Morris Goding  
Access Consulting

29-57 Christie Street,  
St Leonards NSW 2065

## **Access Review – DA 2**

18 August 2020

DRAWING  
DEVELOPMENT APPLICATION  
BASEMENT 01  
**DRAFT**  
STATUS  
DA  
PROJECT NO.  
21811  
DRAWING NO.  
DA-08  
ISSUE  
A

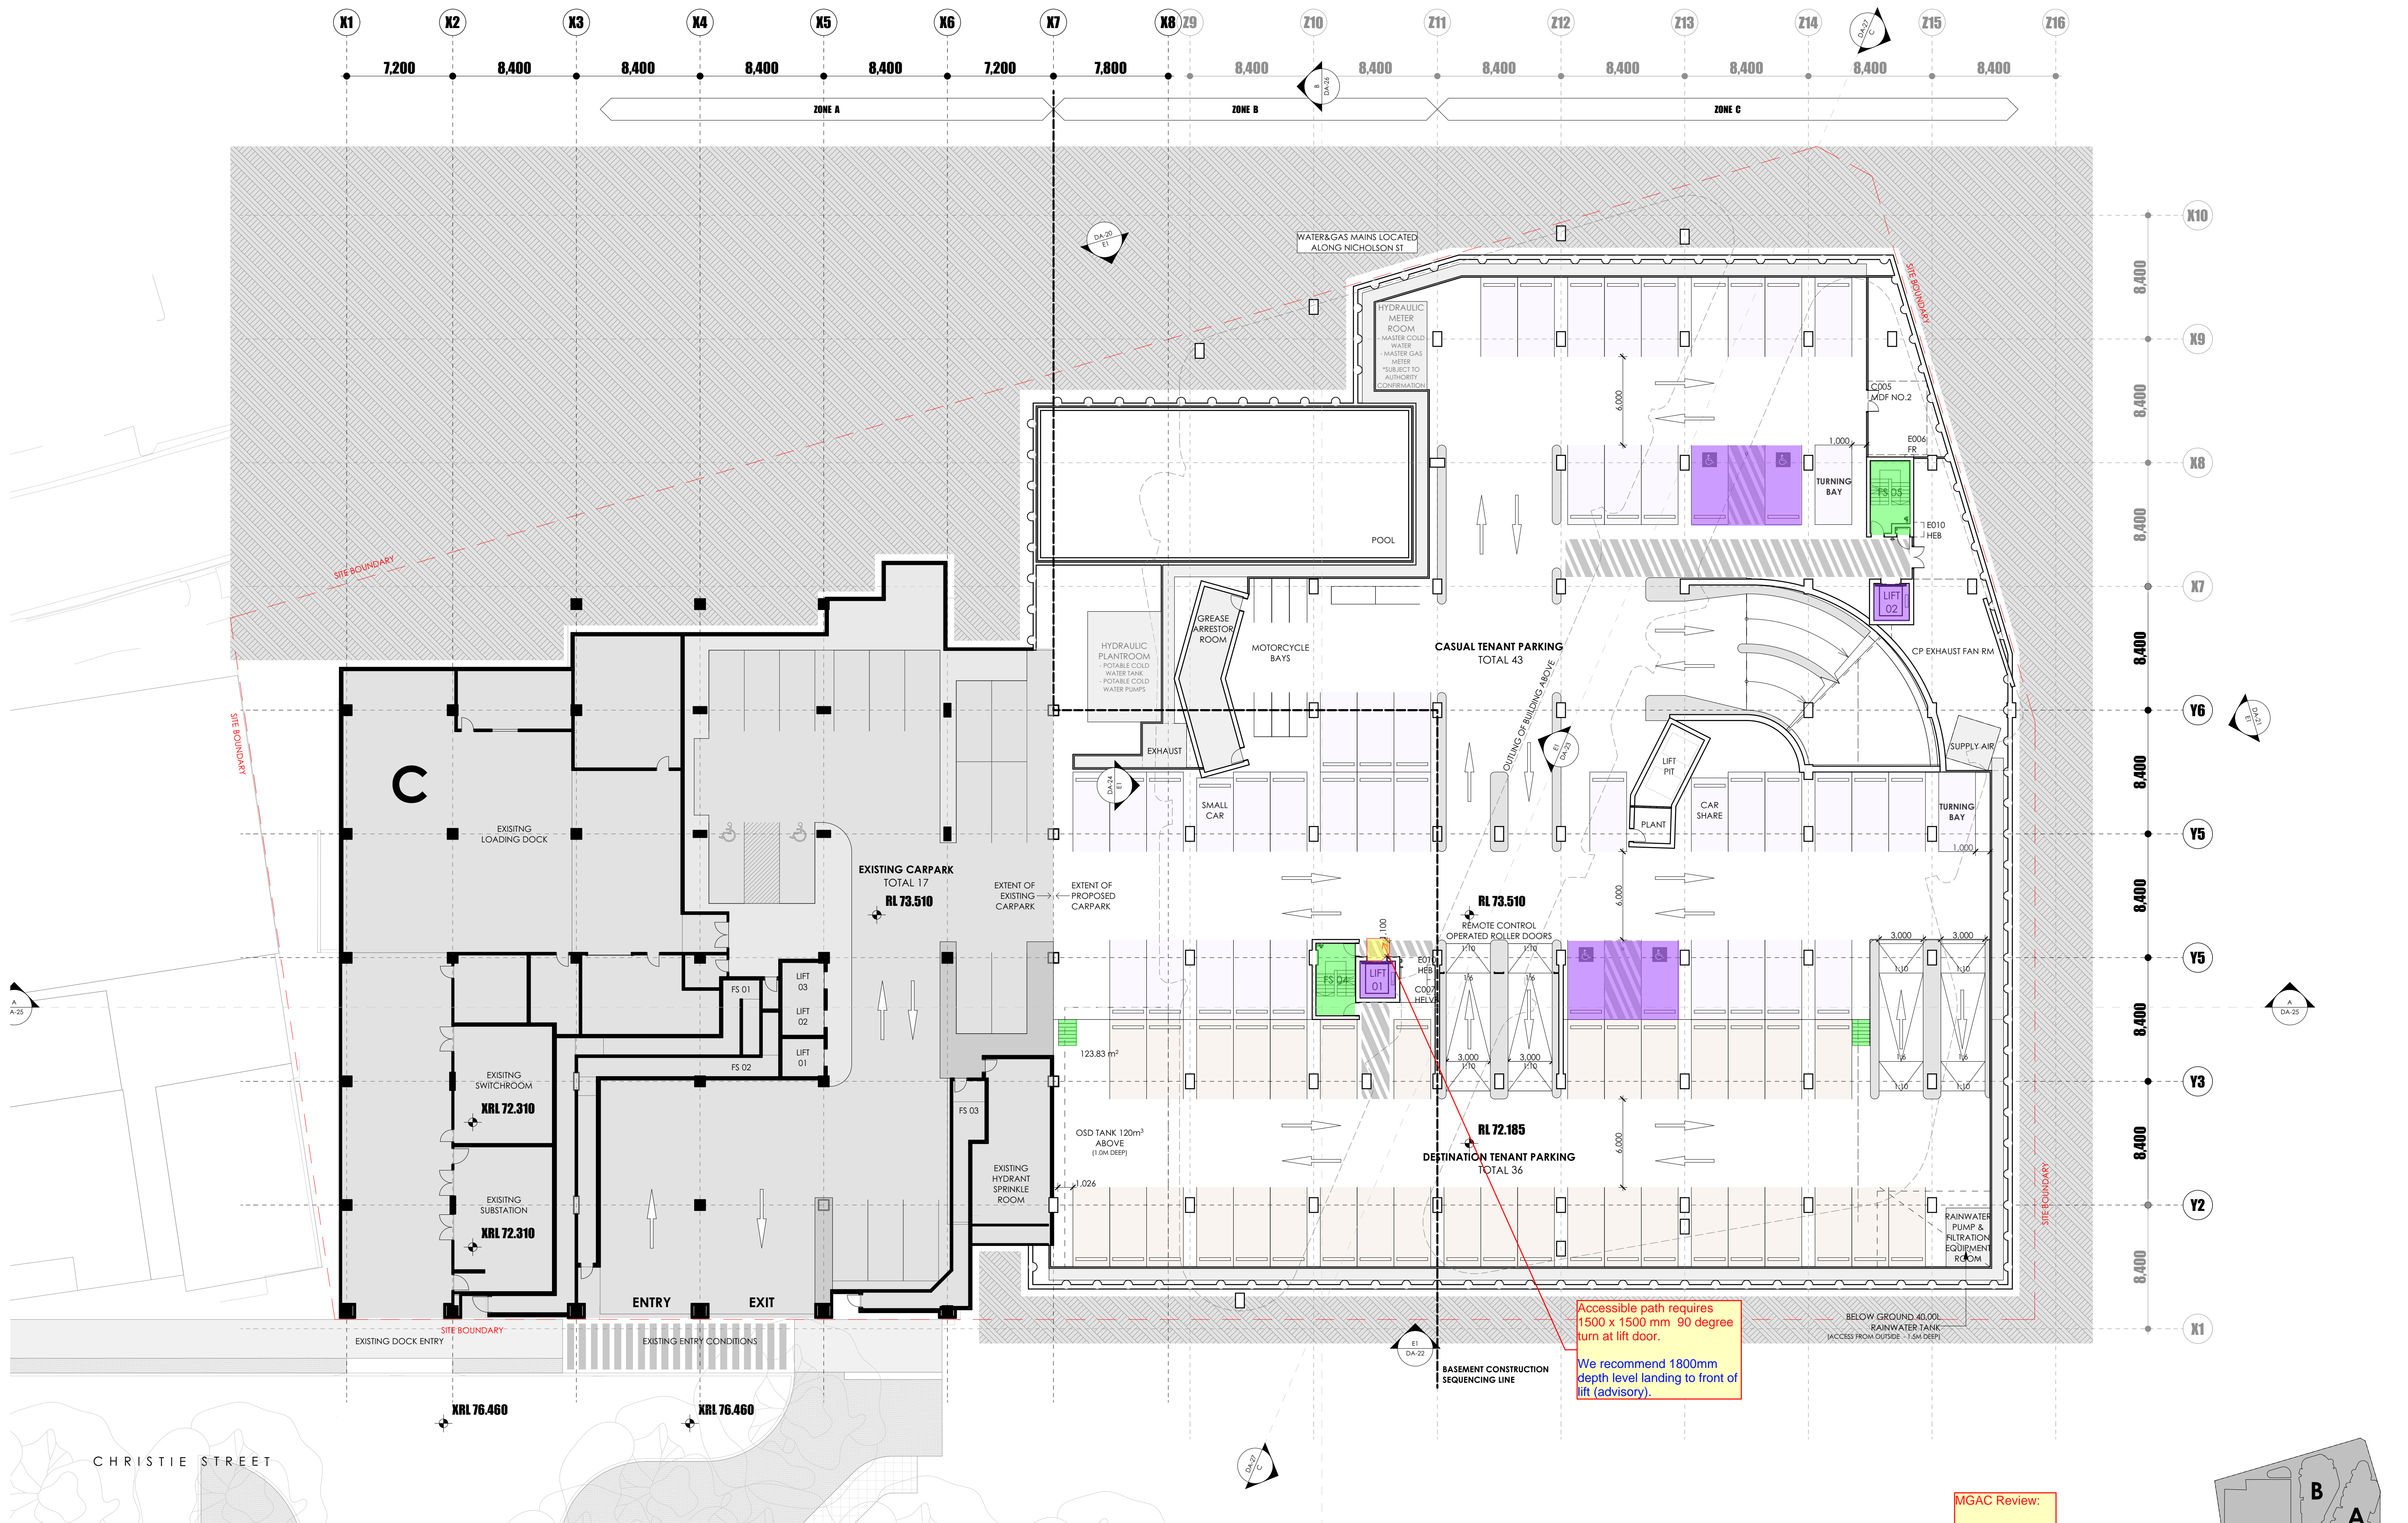
- 90 degree turns at front of lift door – from the carparking spaces to the lifts. Refer marked plans.

*Accessible parking for the different BCA classification and use have yet to be provided.*

*Refer marked plans for further comments.*

DRAWN	APPROVED	PRINT DATE	DRAWING
JF	JF	12/08/2020	DEVELOPMENT APPLICATION LEVELS 02 to 03 PLAN <b>DRAFT</b>
STATUS	PROJECT NO.	DRAWING NO.	ISSUE
DA	21811	DA-13	A

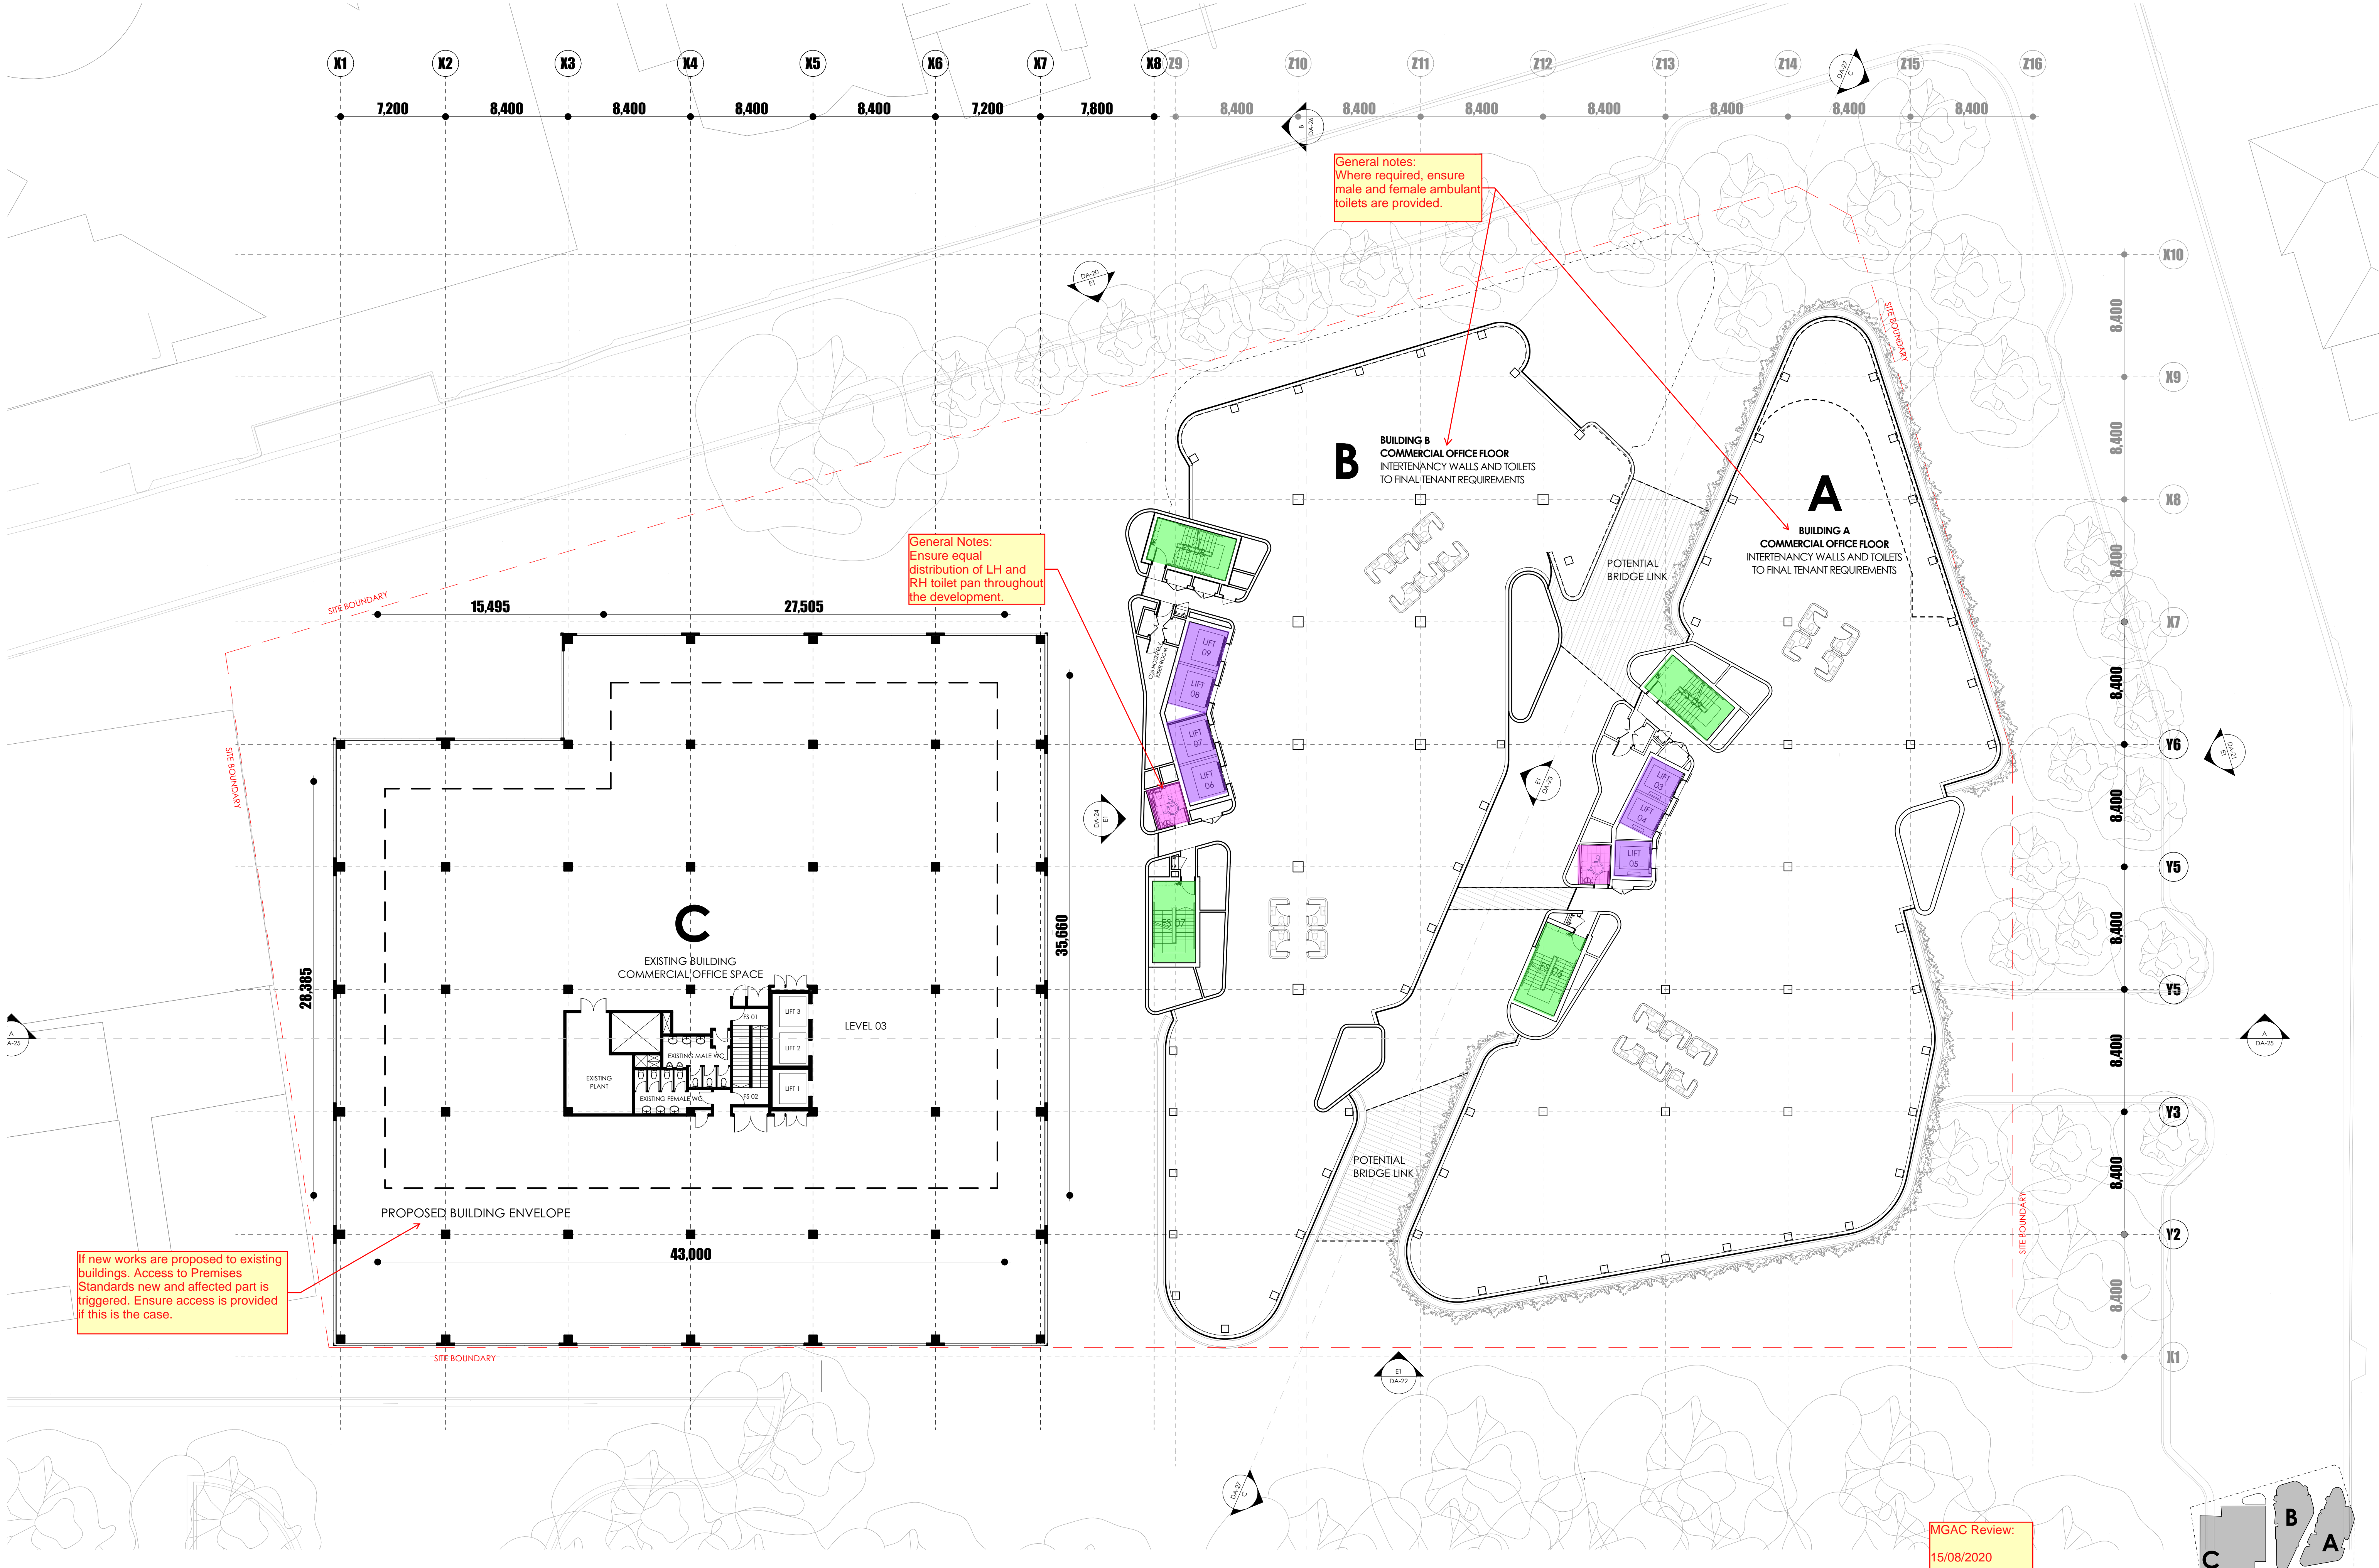
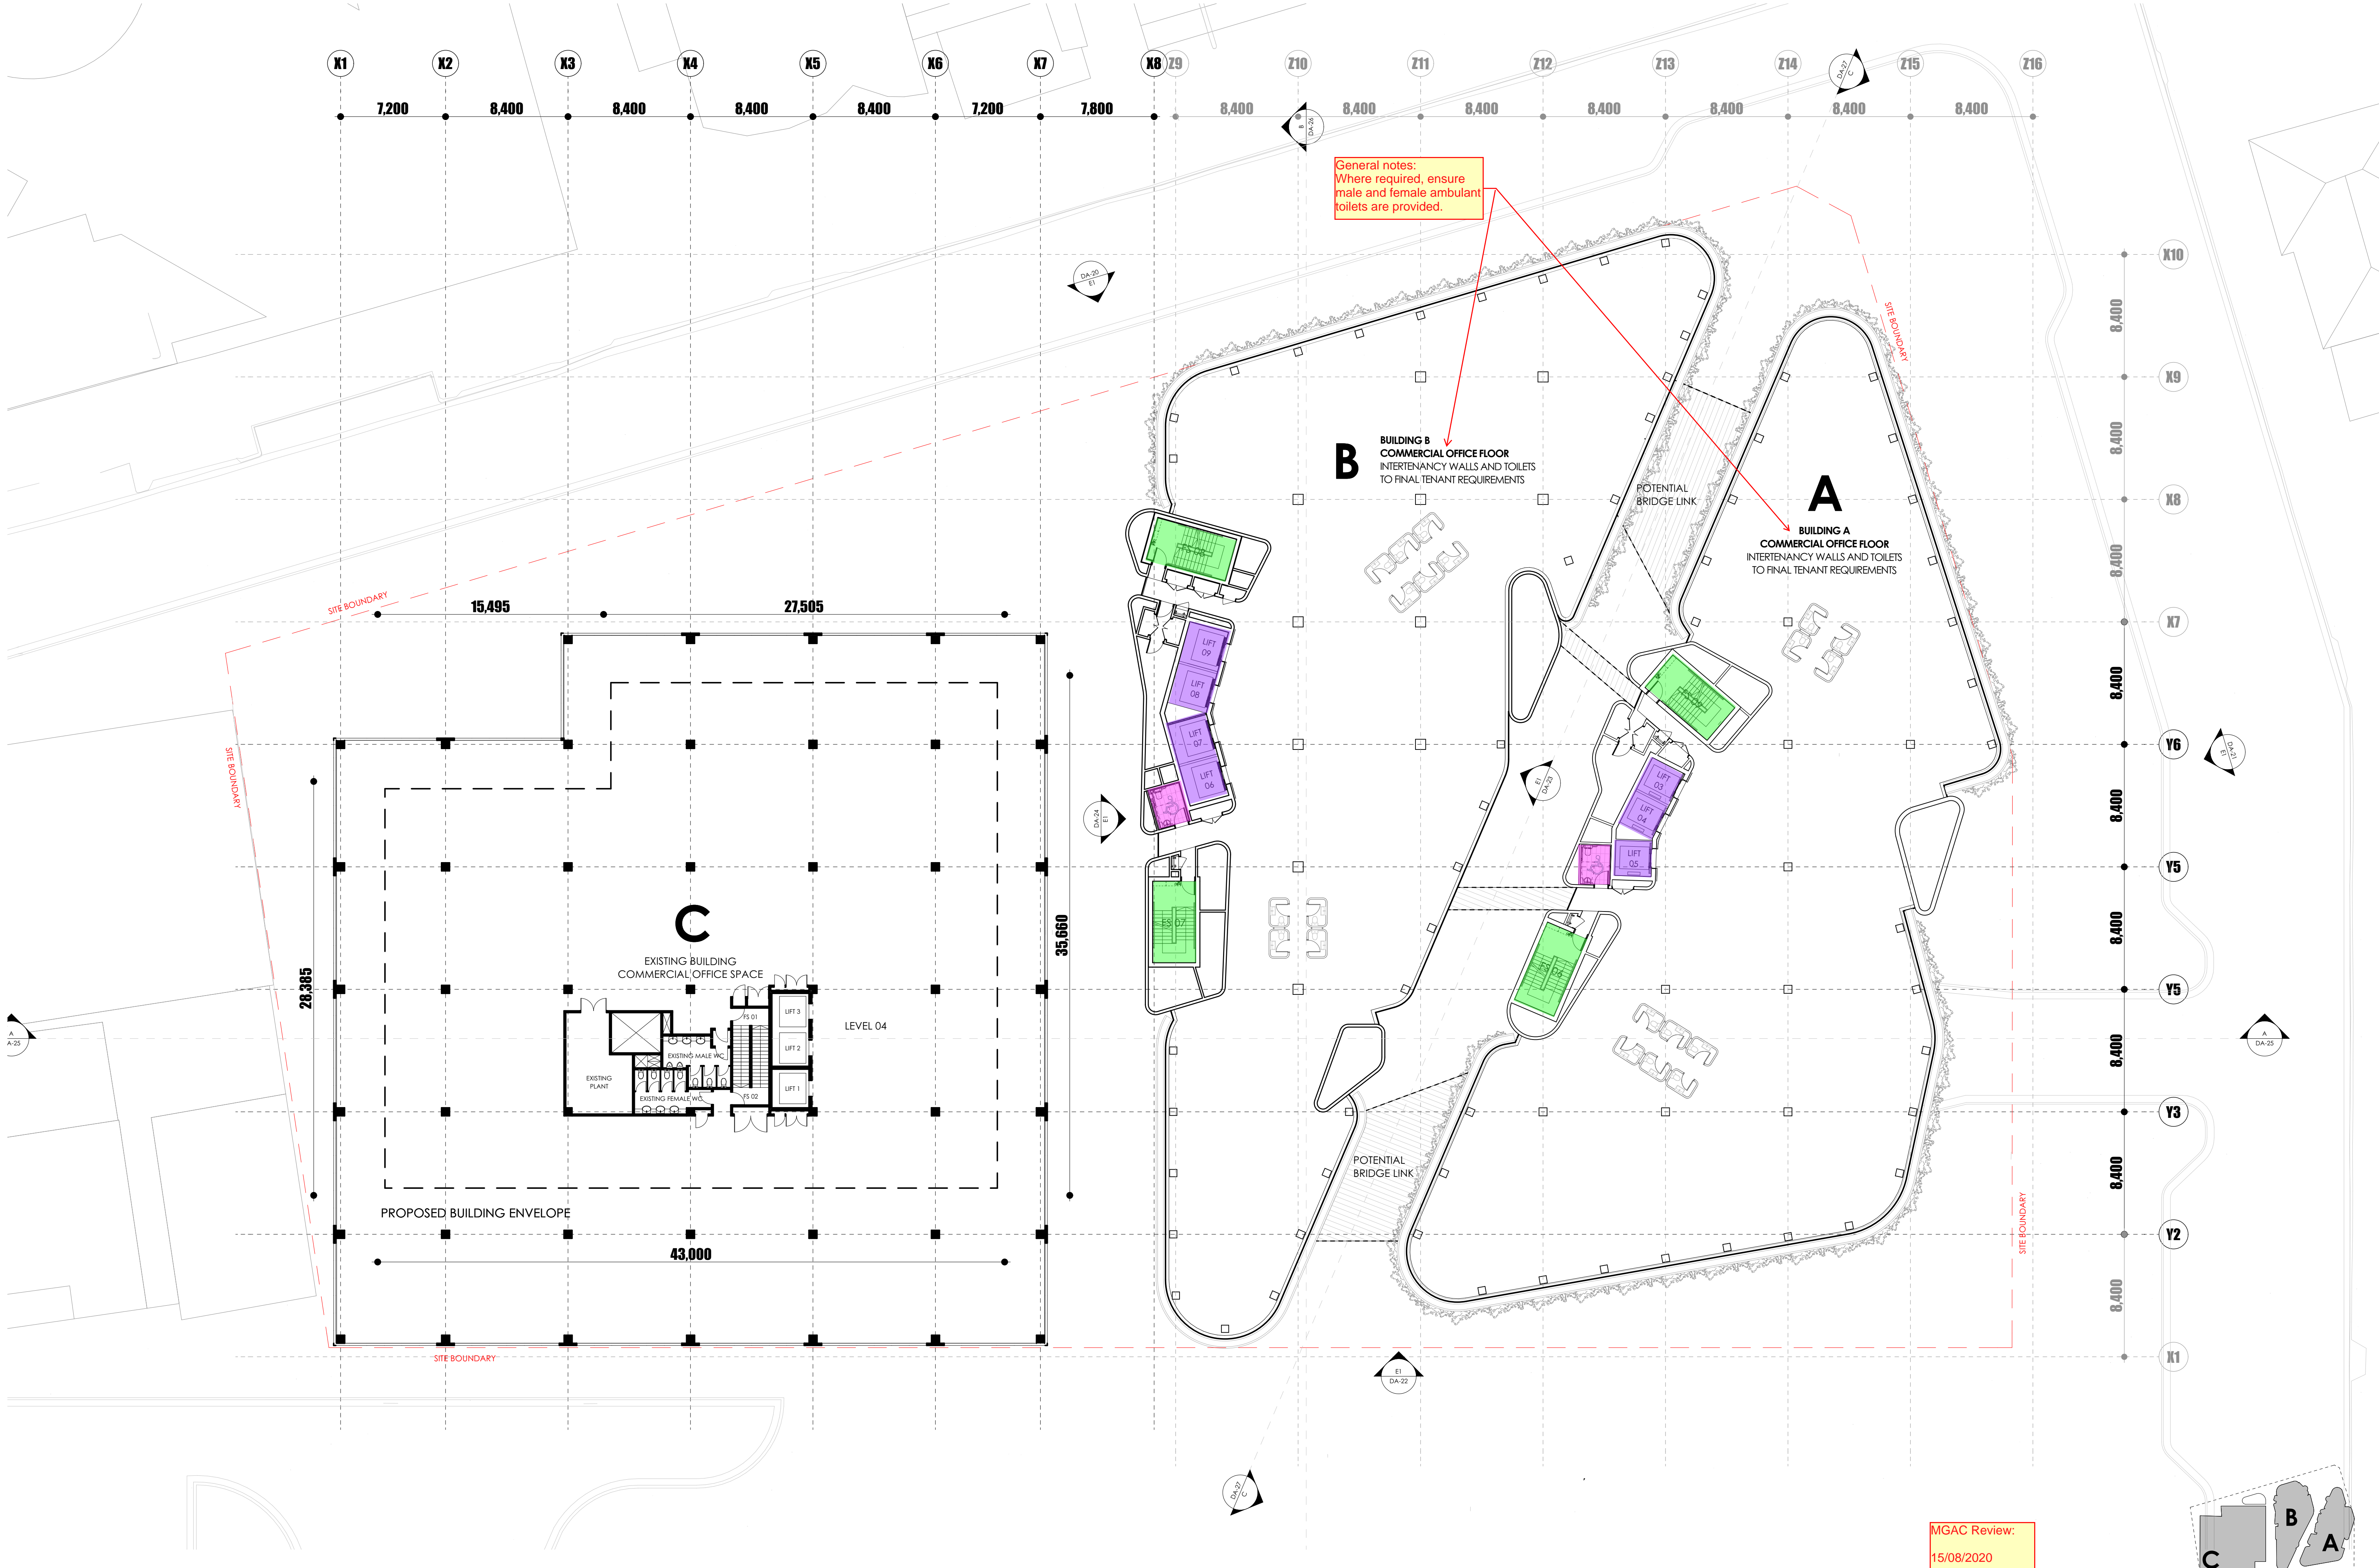
*Signage details is not provided at this early stage. Ensure directional signage is provided at the stair between Building C and B. Refer marked plans.*
